Case No. 00-2647

RE: Variance Case No. 00-2647, Abdel Ismael

LOCATION DRAWING  
SCHULTZ'S ADDITION  
TO  
HILLTOP ACRES  
LOT 7R  
CALVERT COUNTY, MARYLAND

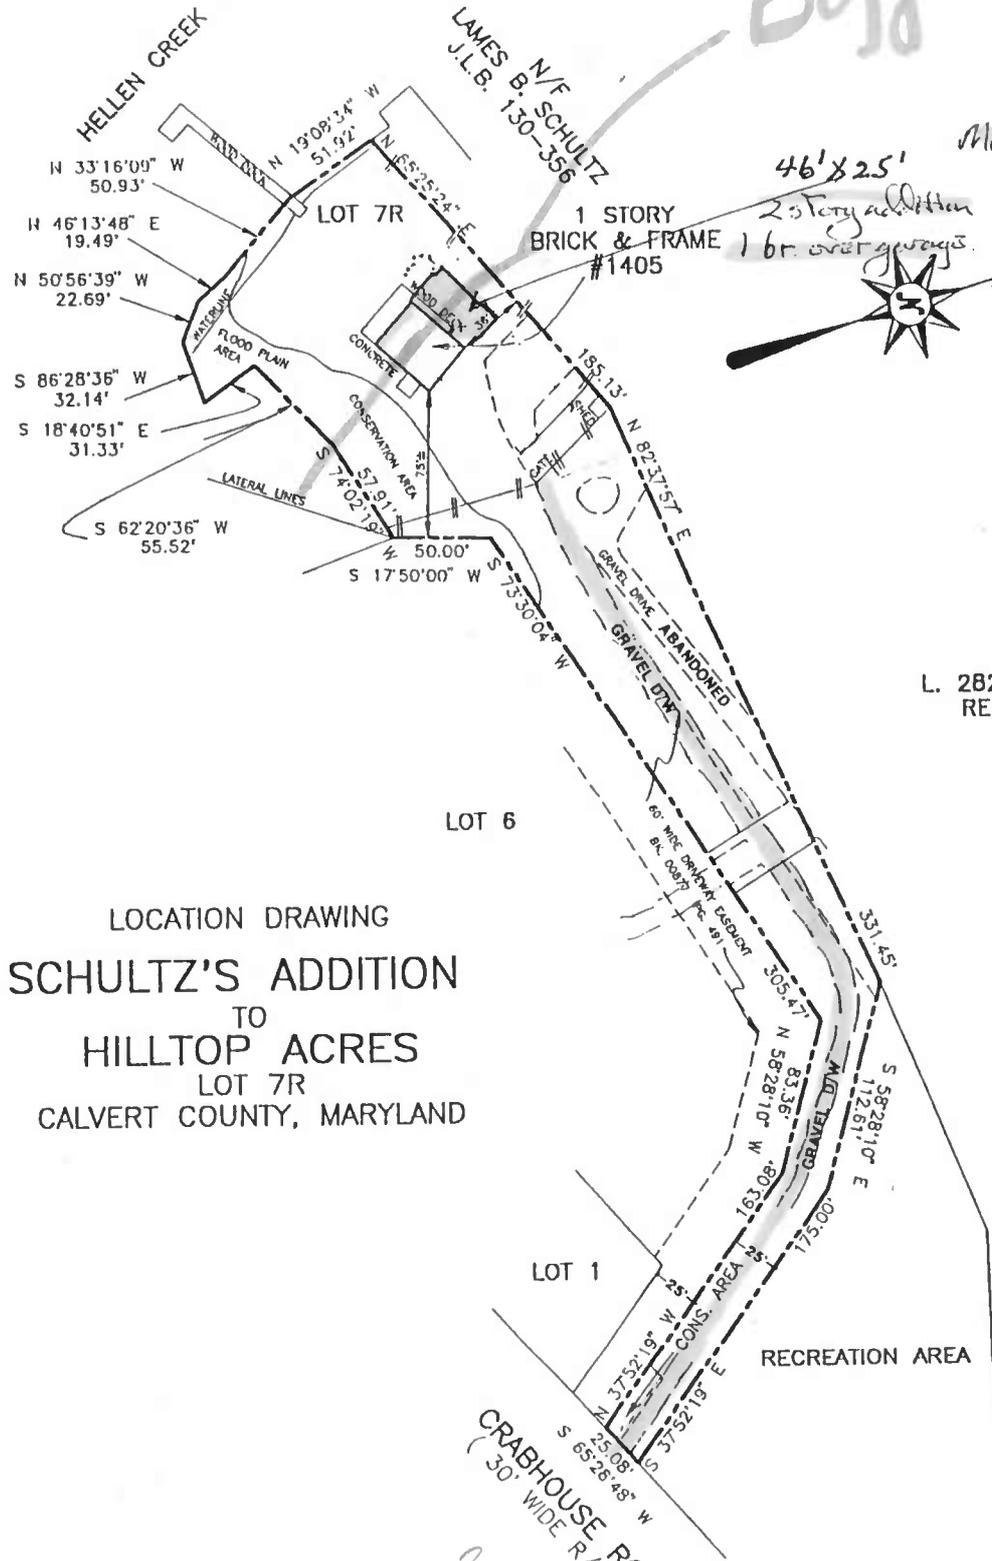
Important information is missing from this variance application. The location of the Buffer is not shown and the amount of existing and proposed impervious surfaces is not quantified. Also, there is no description of any vegetation and whether any clearing or grading is necessary to construct the addition. From the information that was provided, it seems that the addition is a reasonable expansion of living space, though ideally it would be placed outside of the Buffer. Also, I have noted that the health department approved it with a note that says, "must install septic system prior to issuance of construction permits." Where is the septic system being installed? Its location should also be shown on the site plan. It should not be located within the Buffer. Mitigation should be provided for all disturbance within the Buffer at a 2:1 ratio in accordance with the County Zoning Ordinance.

*Trees on site?  
Ant. of impervious?  
Buffer?*
